May 20, 2022

RE: Completeness Response – LU 2022-012 Chestnut Inn and Parkway Village South Self-Storage

Parkway Village South (Lots 1 and 2) Site Plan Review, Major Modification, Conditional Use Permit, and Lot Line Adjustment Applications

P05

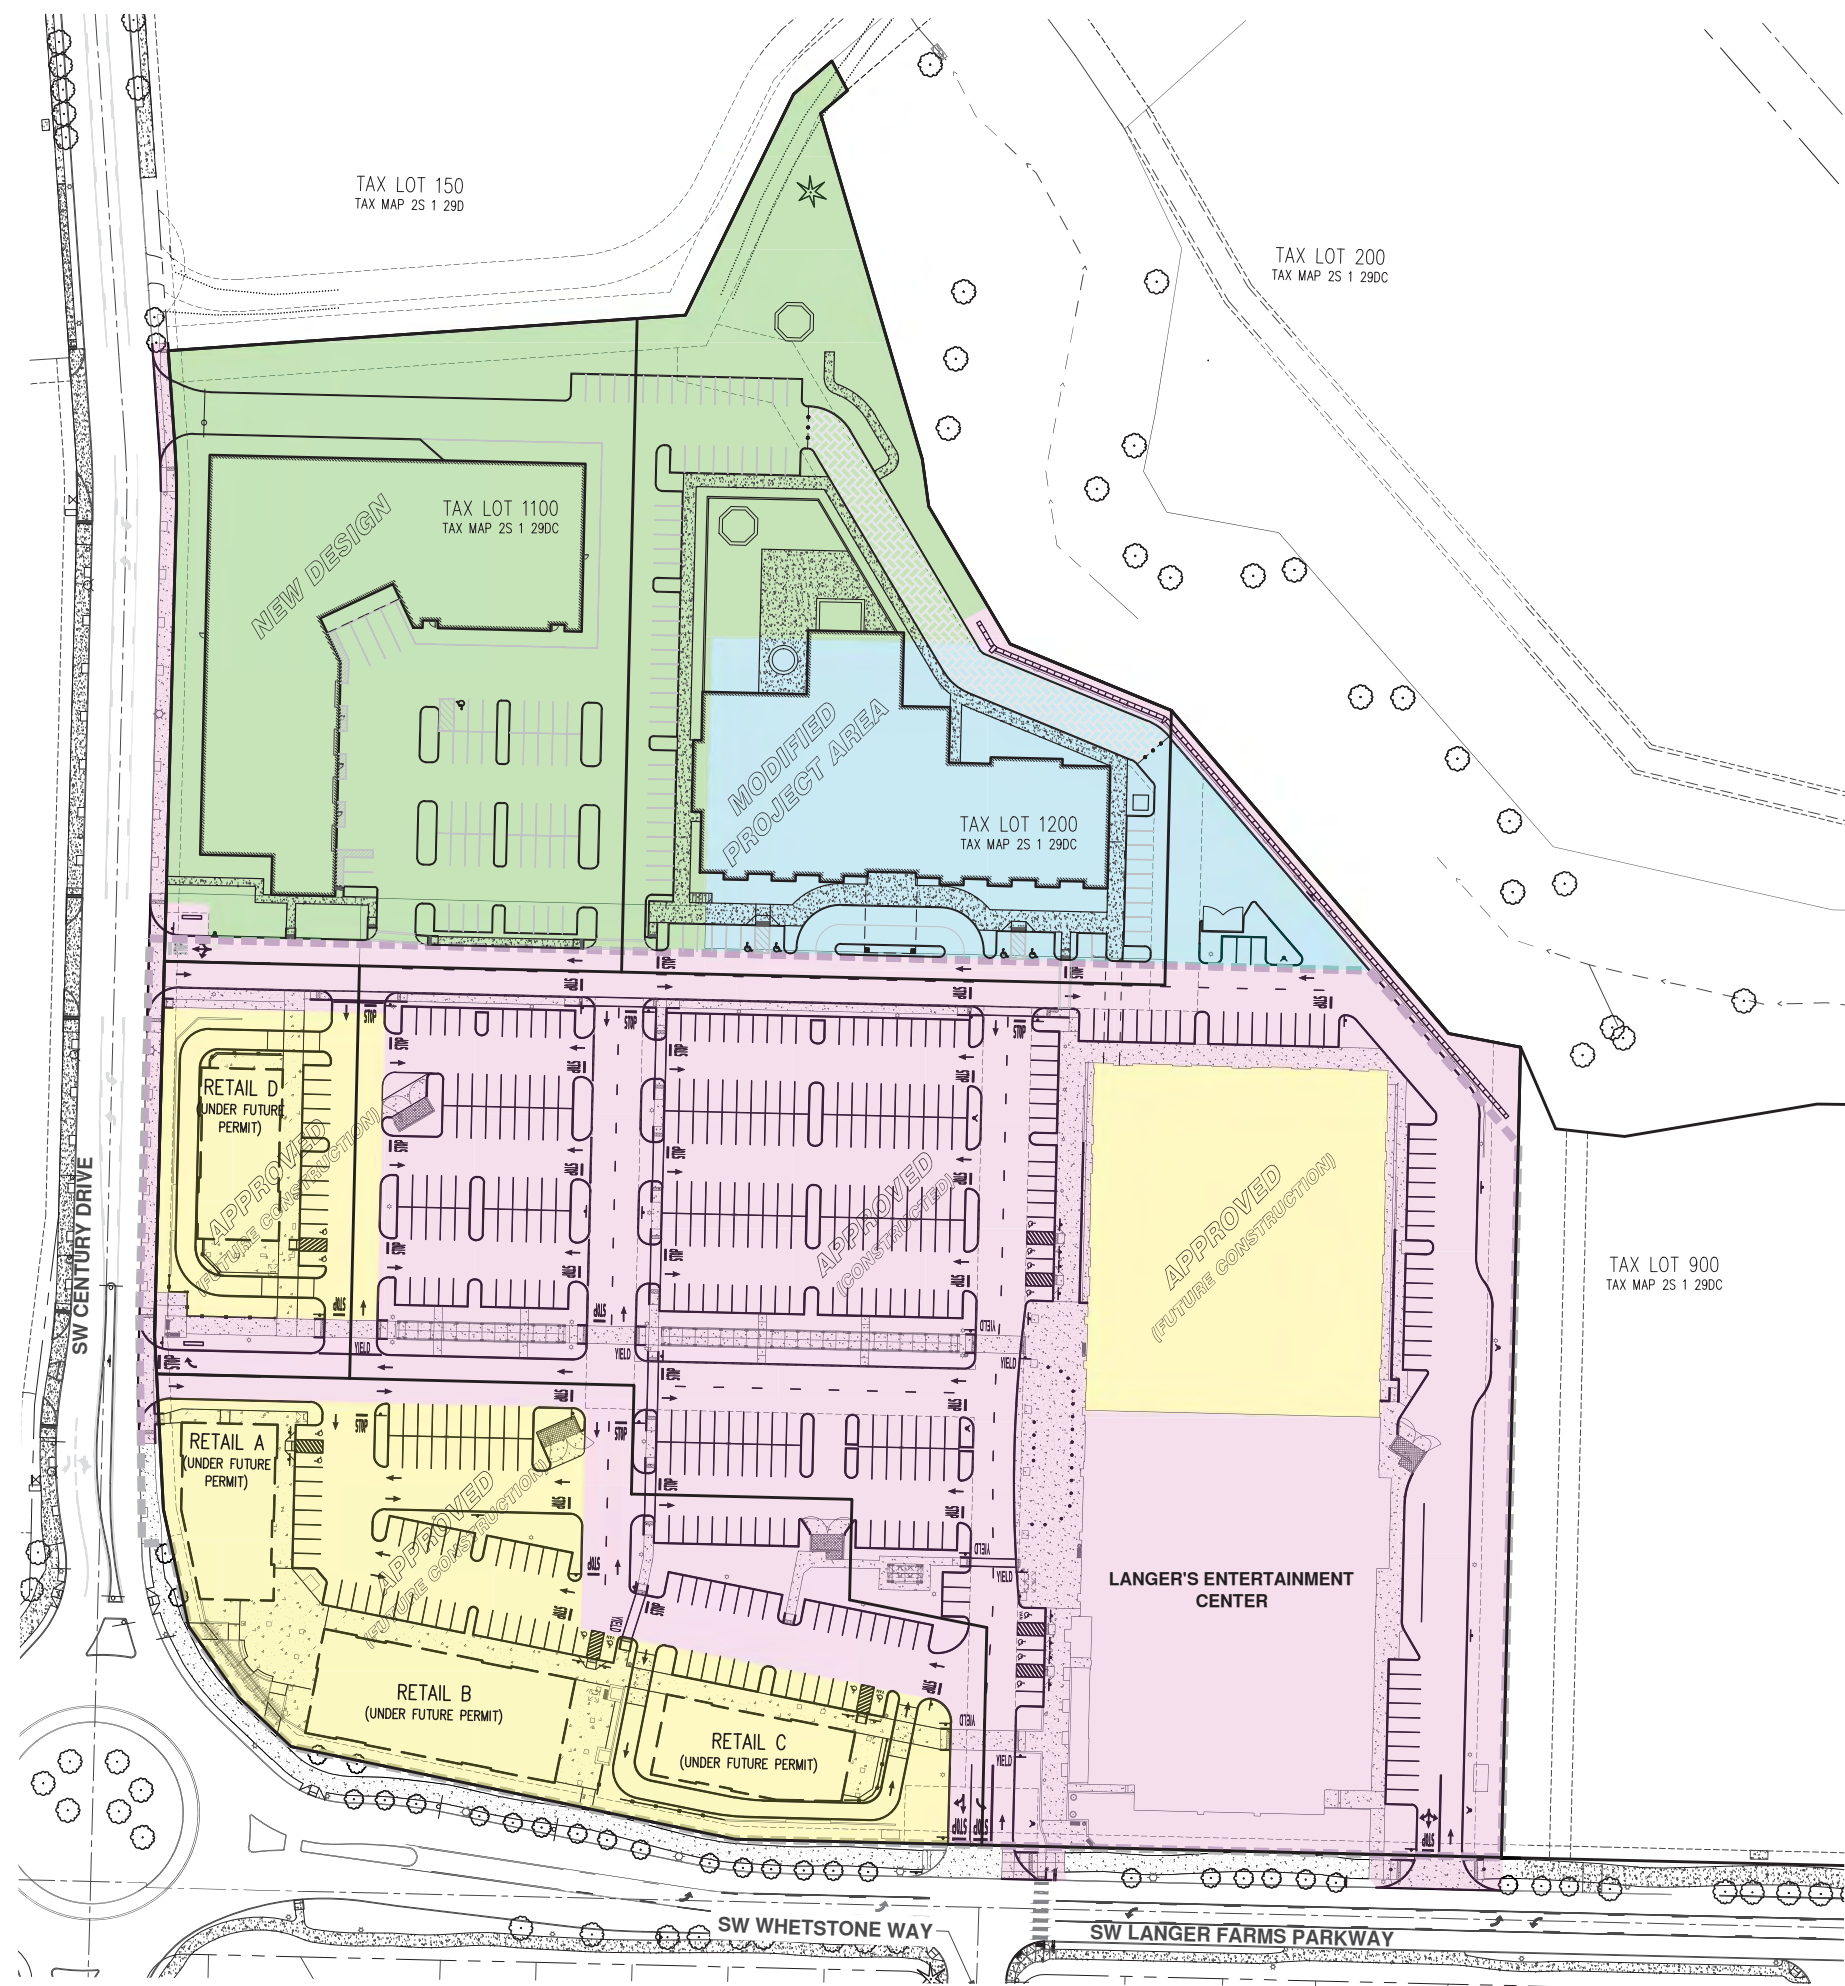
6. *Revise the plans to show the intersection spacing for all driveways on Century Dr. on both sides of the street within 150 ft. of the property line.*

Response: Please see the updated Preliminary Dimensioned Civil Site Plan (Exhibit A), updated to show the intersection spacing for driveways on the north side of Century Drive. All of the requested information has been provided.
